MEYLE
Products

Tie rod end
Tie rod

MEYLE No.
116 020 8228/HD
116 030 8227/HD

Audi A4, A6, A8 / Skoda Superb / VW Passat

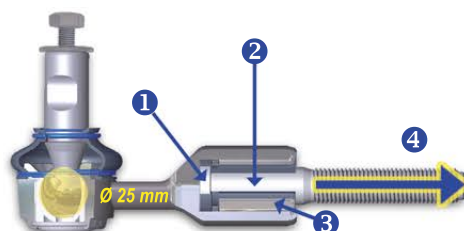
Extreme dynamic and in part high frequent strain causes early damage of the rubber metal bonding between the tie rod end and the threaded bolt, as well as high surface pressure on the tie rod end (head circumference 25 mm)

Noise and play in the steering

- 1 "Anchor"
- 2 Threaded bolt
- 3 Rubber-metal adhesive surface
- 4 Danger of being wrenched

- Use of a full-metal version tie rod end
- Increased diameter of the ball head of the tie rod end to 27 mm

MEYLE-HD version

Maximum stability
(with constant high driving comfort)
